Date: 7/6/2005
To: Paul Patterson
From: Chad Voigt
cc: Terese Gorman, Chuck Soules
Re: Site plan SP-05-40-05, Fairhaven Commercial

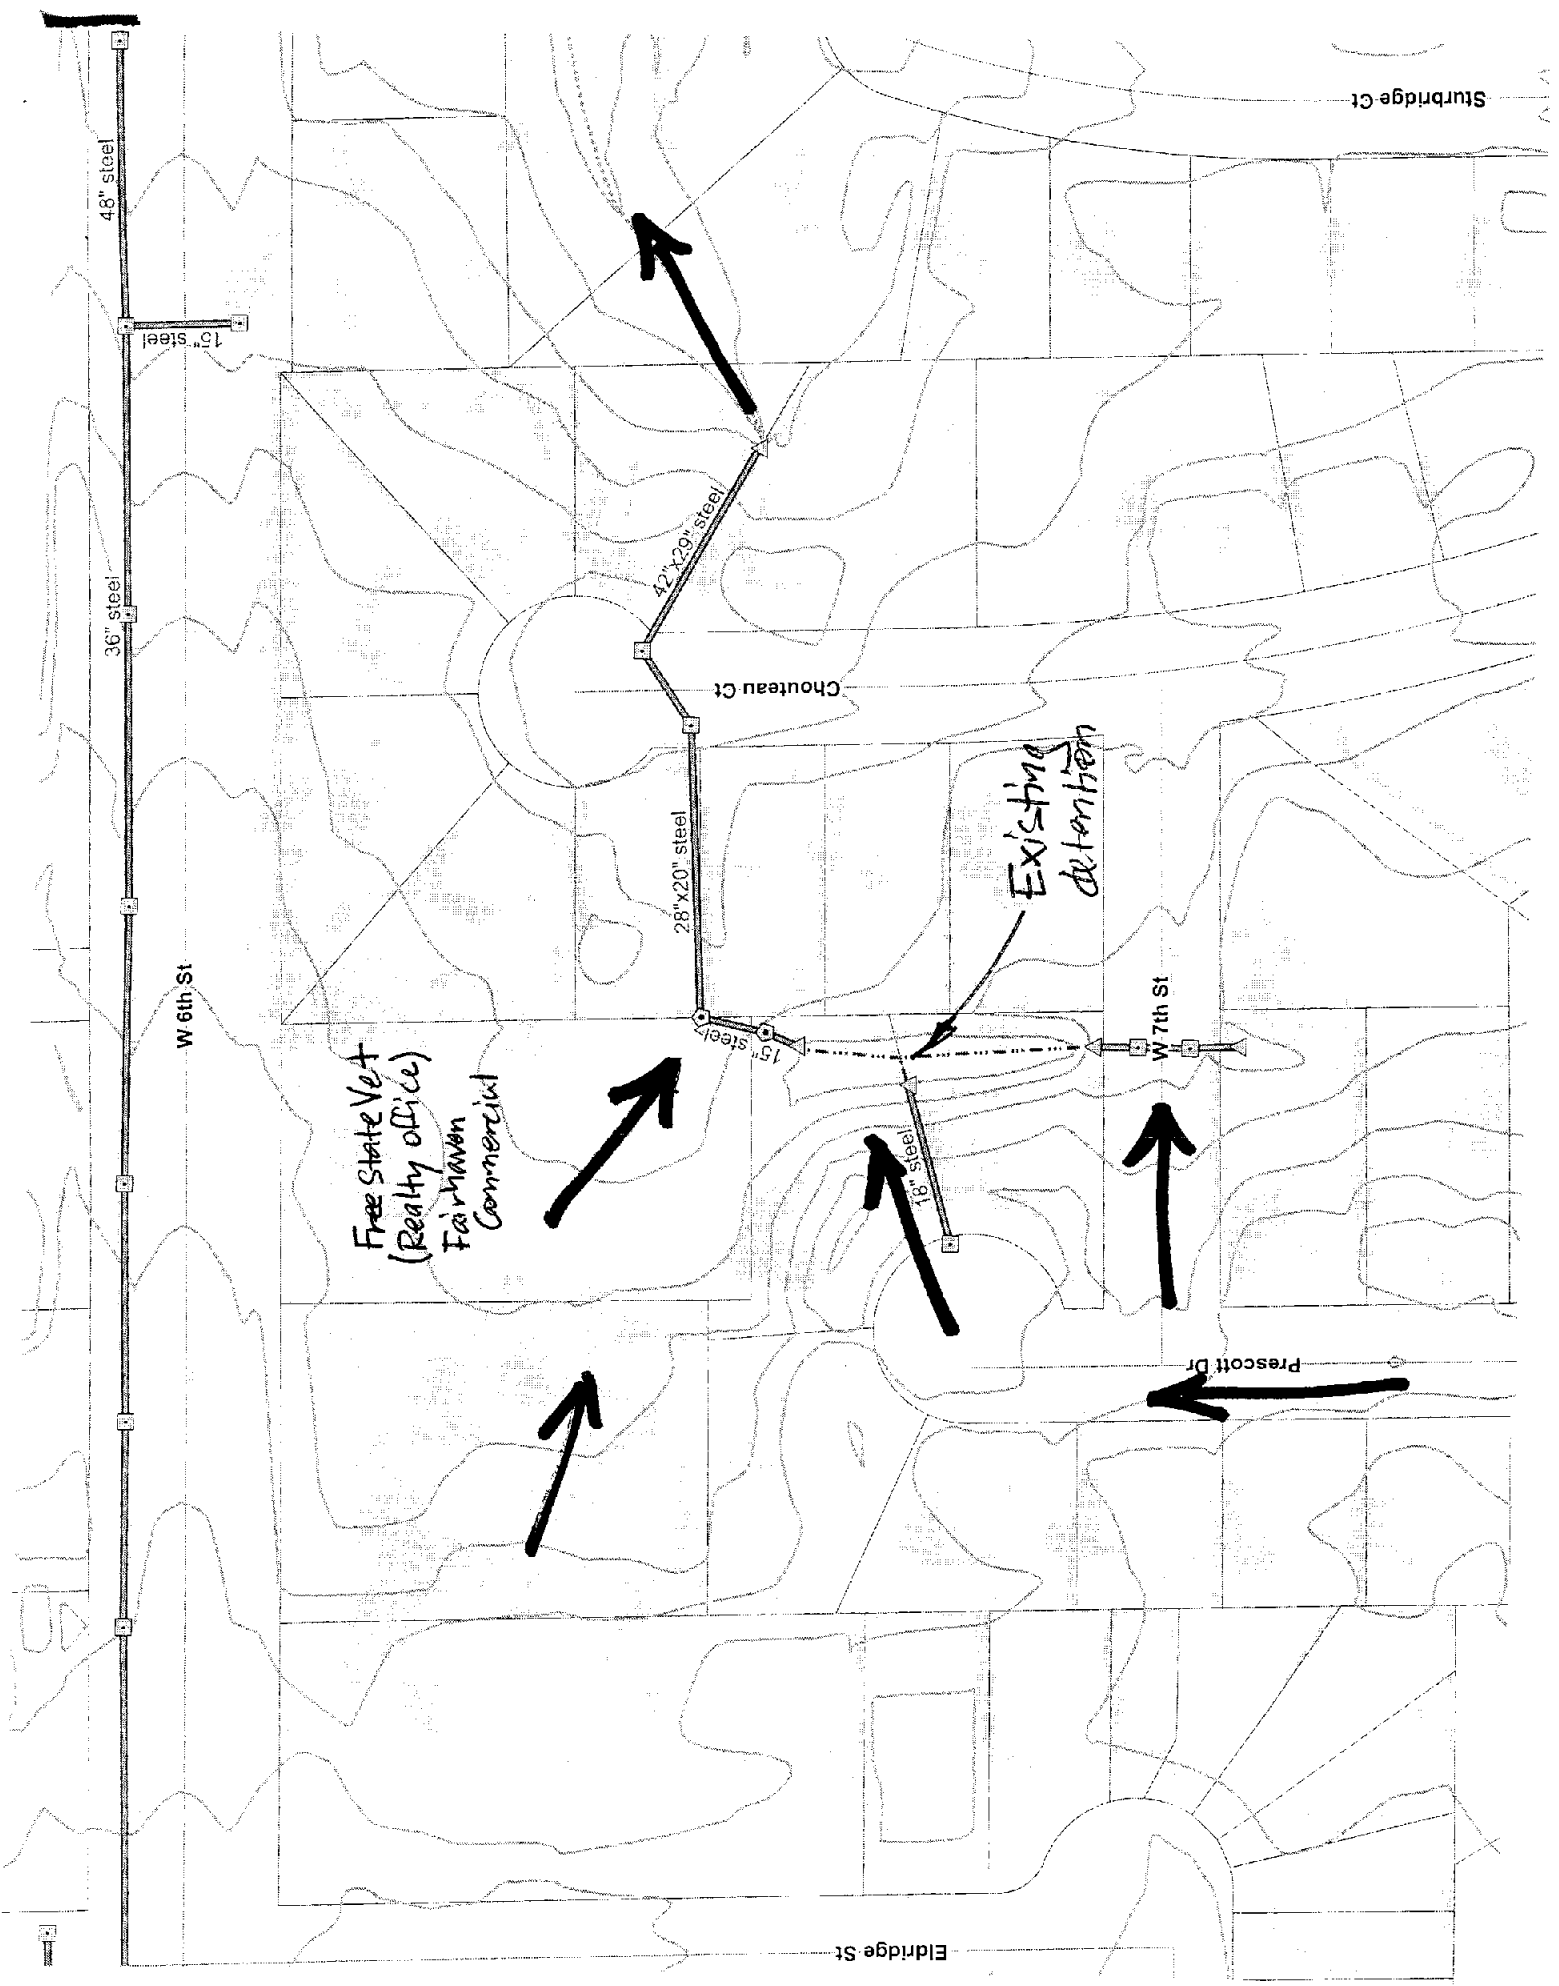
The proposed site plan increases impervious surface on the 0.8 acre parcel; therefore a drainage study was required. The drainage study proposes to add stormwater detention at the point of discharge to compensate for the increased runoff. The proposed detention basin will replace and expand the existing detention basin constructed in 1997 with Prescott Place Subdivision. The plan makes more efficient use of the detention area by removing the existing berm that straddles the property lines:

Existing detention - Prescott Place Subdivision	7,841 cubic feet storage
Proposed detention - Fairhaven	14,680 cubic feet storage

The drainage study also provides a specific analysis of the downstream storm pipe that runs east to Chouteau Court. With the proposed development and detention in place, the existing downstream pipe will handle the 100-year storm event:

Existing pipe capacity:	20.4 cubic feet per second
Proposed 100-year discharge:	12.8 cubic feet per second

Based on these favorable conditions, we approved the current drainage study on June 10, 2005. A copy is attached for your reference.
